Access Compliance Report

Public Rights-of-Way

(Curb Ramps)

Intersection ID: 47297	Main Street: LELA_AV	Cross Street: HURSTON_CR	Location: NE
ADA ID: 20D4813D6396	Ramp Type: Perp	Initial Pass/Fail: Fail	Overall Compliance: No
		Severity Score: 8.75

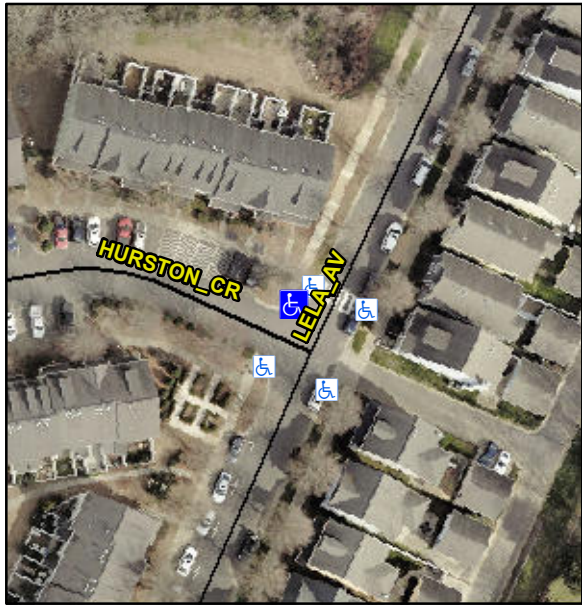
Codes/Mitigation Info/Possible Solution			Field Measurements/Component Compliance					
	Possible Solutions:		Compliance	Description	Data	Compliance	Description	Data
	Remove & Replace Entire Ramp.		N/A	Ramp Length (in)	68.0	Yes	Ramp Slope (%)	5.7
			No	Ramp Width (in)	47.5	Yes	Ramp XSlope (%)	1.8
			N/A	Flare Type LT	N/A	N/A	Flare Type RT	N/A
			N/A	Flare Slope LT (%)	N/A	N/A	Flare Slope RT (%)	N/A
			N/A	Flare Traversable LT?	N/A	N/A	Flare Traversable RT?	N/A
			N/A	Landing Length (in)	N/A	N/A	DWS Provided?	N/A
			N/A	Landing Width (in)	N/A	N/A	DWS Contrast?	N/A
			N/A	Landing Slope (%)	N/A	N/A	DWS Length (in)	N/A
			N/A	Landing X Slope (%)	N/A	N/A	DWS Full Width?	N/A
Surveyor Notes: N/A			N/A	Landing Curb? (Y/N)	N/A	N/A	DWS Offset (in)	N/A
			N/A	Shared Landing?	N/A			
	PROW/ADA:		N/A	Gutter Ponding?	Yes	N/A	Gutter Slope (%)	N/A
	Not Found, R304.5.1		N/A	Gutter Lip Ht (in)	N/A	N/A	Gutter X Slope (%)	N/A

N/A	Painted X Walk1?	No	N/A	Painted X Walk2?	N/A
				X Walk 1 Direction	To SW		X Walk 2 Direction	N/A
			N/A	X Walk 1 Width (in)	N/A	N/A	X Walk 2 Width (in)	N/A
				X Walk 1 Slope (%)	1.8		X Walk 2 Slope (%)	N/A
				X Walk 1 X Slope (%)	0.4		X Walk 2 X Slope (%)	N/A
			N/A	Ramp inside XWalk1?	N/A	N/A	Ramp inside XWalk2?	N/A
				Road Slope (%)	N/A	N/A	Clear Space?	N/A
				Road X Slope (%)	N/A	N/A	Clear Space to XWalk (in)	N/A
			N/A	Any Obstructions?	N/A	N/A	Storm Grate/Utility Hazard?	N/A
				Obstruction Type			Storm Grate/Utility Type	
					N/A			N/A
						Yes	Surface Condition? (G/P)	Good
Total Cost:		\$	1850.00
